SUBJECT: FWD TRANSIT PUMP / BRAKE LINE LOCATION

SERVICE MEMO. 14-01-23

Picture 1

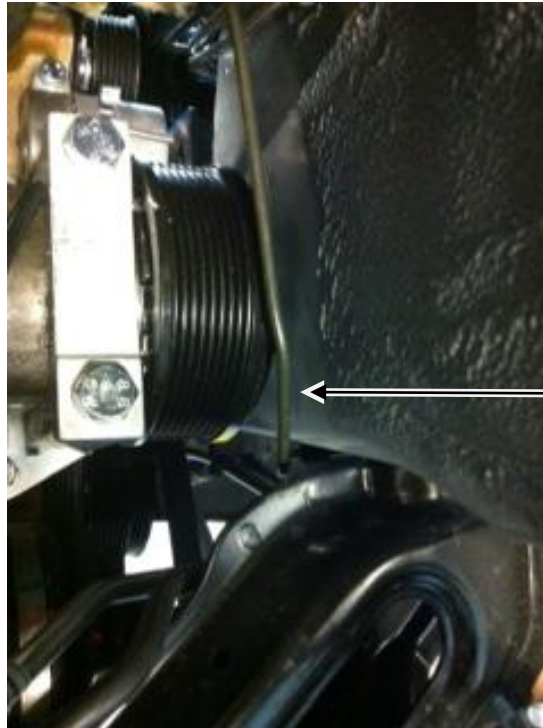
We have had one reported incident that the hydraulic pump fitted to the rear of the engine can come into contact with one of the steel brake lines even though the pump is fitted to the exact same position that Ford fit the air conditioning pump.

Steel hose
Needs to be
approx
30mm away
from pulley

1. Remove plastic clip as shown in figure below, drill hole to 7mm and fit a 5mm nut insert.

2. Push pipe to rear of the vehicle away from pulley and fit "P Clip"

3. Relocate rubber grommet from wheel side of chassis to engine side.
